DECISION 2005.01
RESPECTING
THE AMENDMENT
TO THE
TERRA NOVA DEVELOPMENT PLAN

JUNE, 2005

Terra Nova Development Plan Amendment Decision 2005.01

Figure 16: Far East Proposed Delineation Wells from Reservoir Basis for Terra Nova Development (Source: Petro-Canada 1998)

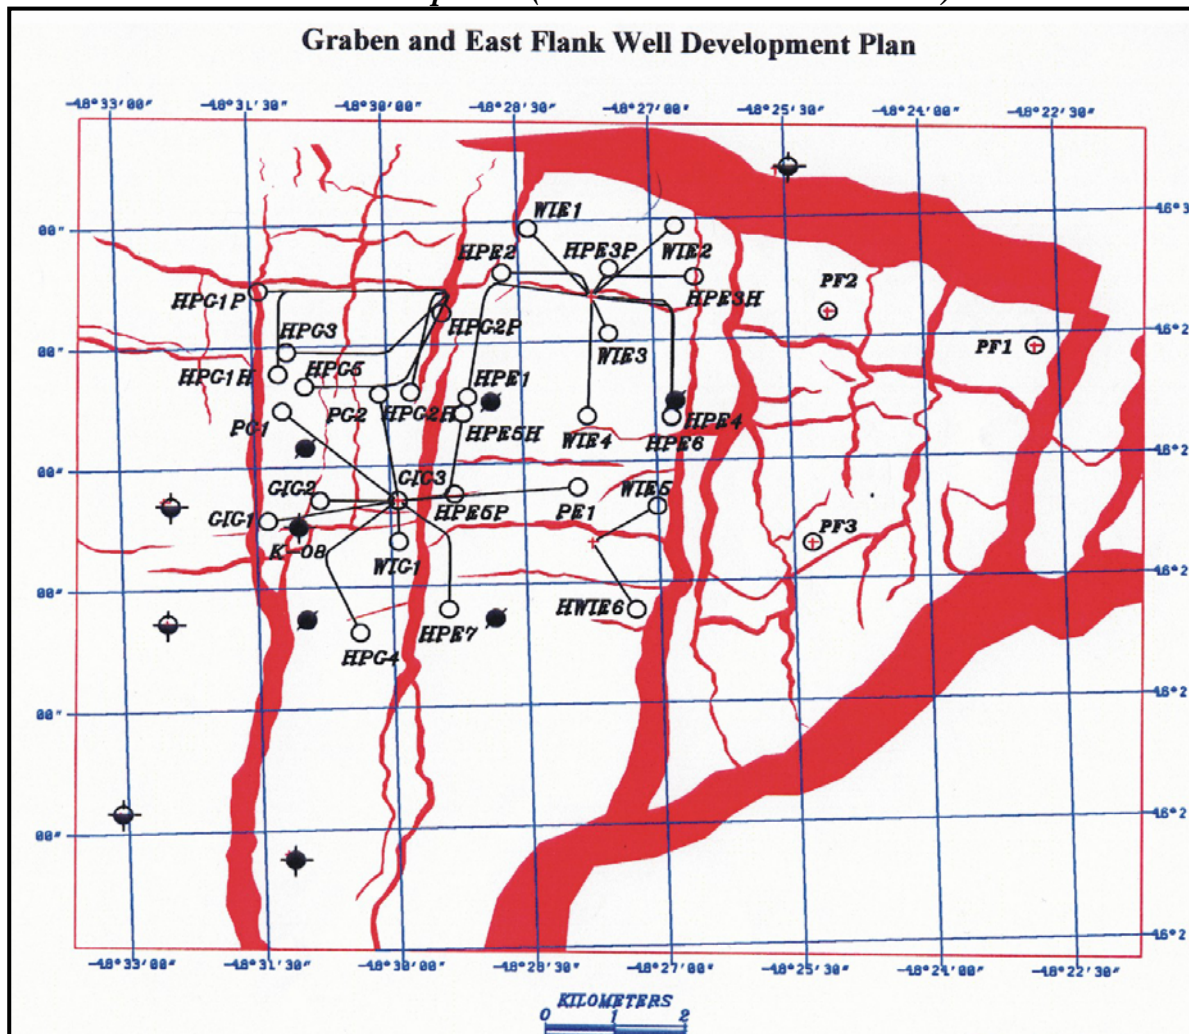
In the document "*Reservoir Basis for Terra Nova Development*" submitted to the Board in March, 1998, the Proponent indicated plans to drill three delineation wells in the Far East area of the field. Figure 16 shows the location of these three delineation wells as presented by the Proponent. The Board's technical staff note that the Proponent has prepared a glory hole in the Far East area and drilled three development wells, one of which was drilled shortly after the initiation of production at the field.. Only one of these development wells, PF2, has been drilled at a location consistent with the proposed delineation wells in the reservoir basis for Terra Nova Development.

It is the view of the Board's technical staff that if the three stand-alone delineation wells proposed for the southern and northern areas of the Far East had been drilled, information necessary to support a comprehensive development plan for the Far East region would have been acquired. In essence, the approach taken by the Proponent to delay delineation drilling has likely led to unnecessary capital expenditures that have burdened the project. Despite the three wells drilled to date, the Far East area is still not adequately delineated. Also, with the approach taken, the development wells are not ideally located and may not be of use in any future development. Further, if a drill center is not installed in the Far East glory hole, this capital expenditure will have been unnecessary. Not including the cost of the glory hole, this amounts to about \$83 million in drilling expenditures.
